ACCESS (CURB CUT) APPLICATION

TOWN OF EAST MONTPELIER

Property Location: North Street

**Haynes -- Upper North Street
East Montpelier**

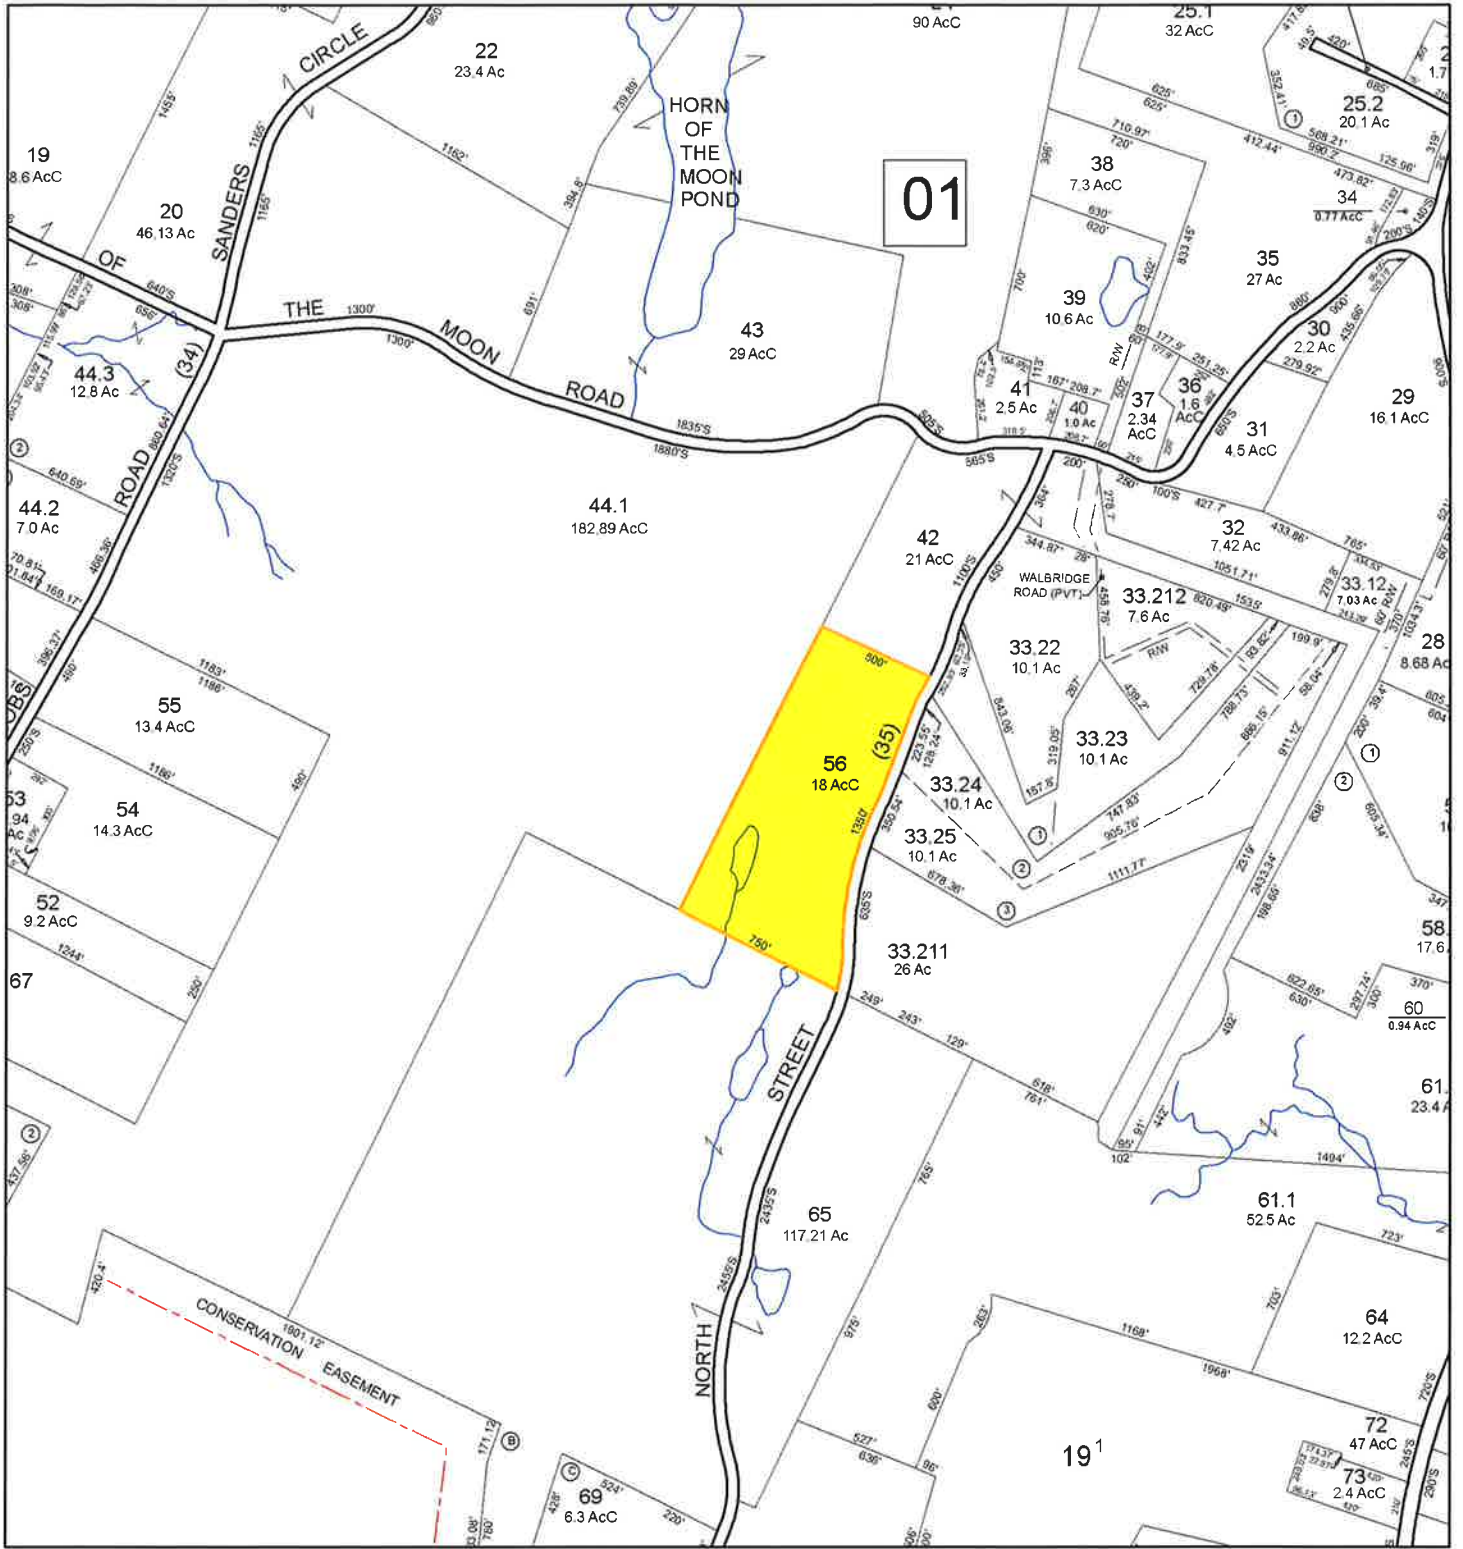
Proposed access meets applicable sight distance standards. Comments: Existing culvert needs to be replaced. Good sight distance 330' work

Existing culvert in poor condition needs to be replaced with a 15" x 40" heavy plastic culvert inlet and outlet headwalls. all excavated material needs to be seeded and mulch
